ON-SITE SEWAGE DISPOSAL SYSTEM HOWARD COUNTY HEALTH DEPARTMENT BUREAU OF ENVIRONMENTAL HEALTH

SUBDIVISION: Swann Farm LOT NUMBER: _____

ADDRESS: Route 108 PROPERTY OWNER: William Swann

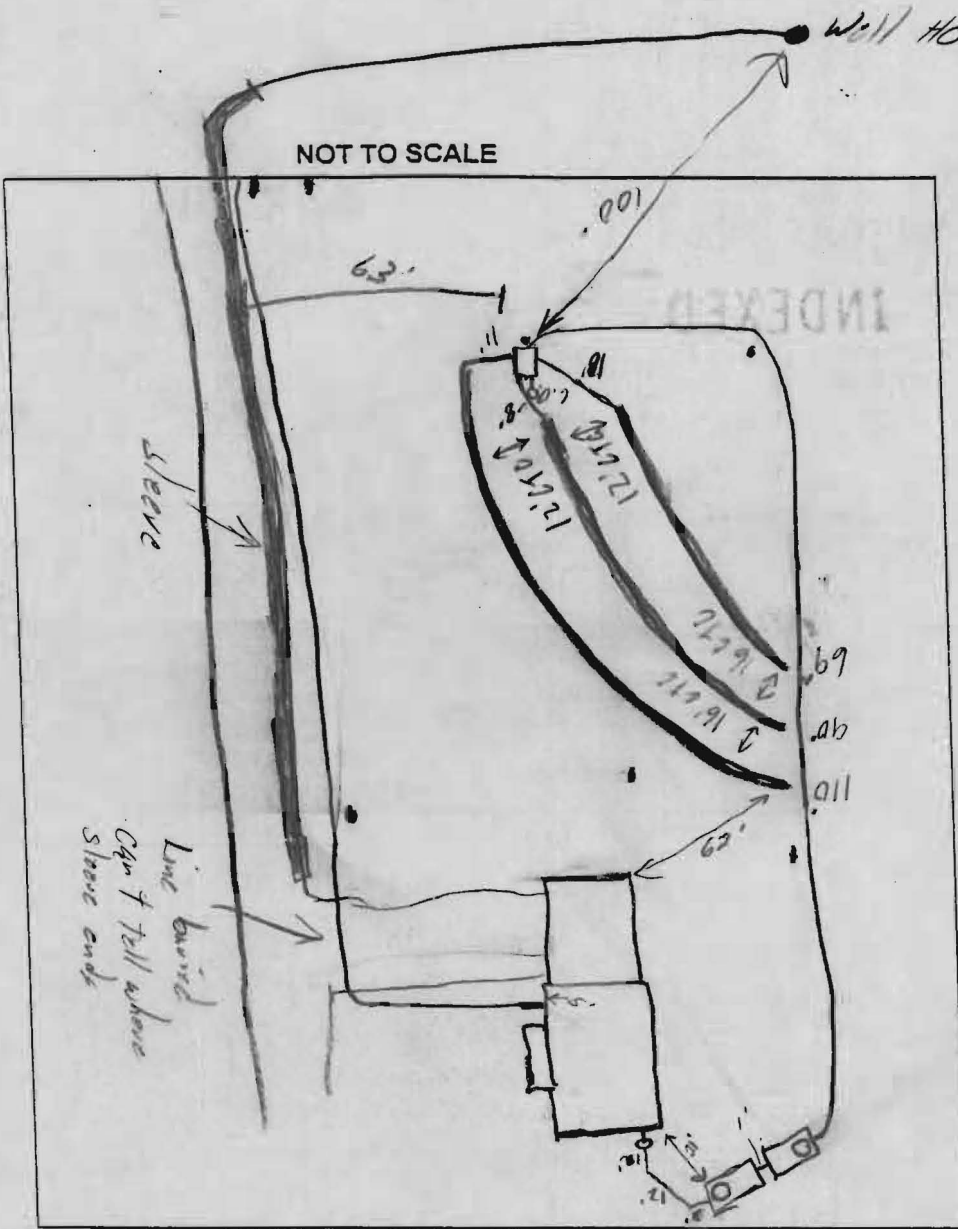
TRENCHES:	Trench to be 3.0 feet wide. Inlet 5.0 feet below original grade. Bottom maximum depth 7.0 feet below original grade. Effective area begins at 1.5 feet below original grade. 2.0 feet of stone below distribution pipe.
LOCATION:	Place the distribution box 70' from the left lot line and 100' from the front lot line closest to the road. Run trenches on contour.
NOTES:	Basement service by gravity is proposed. <u>WELL LINE TO BE SLEEVED WHERE < THAN 10' TO SDA.</u>

PRE-CONSTRUCTION INSPECTION: 3/20/02 Layout for B.P. Not sure of House Conn. (S)

INSPECTION COMMENTS: 4/3/02 OK to cover all work. Grade over tanks needs to be cut down to approx 3". Pump & Alarm tests needed (S) 4/4/02 T/C to bldr. for details on grading @ tanks (S) 4/9/02 Can't tell if sleeve runs under drive way (S) 4/28/02 Pump & Alarm test OK (S)
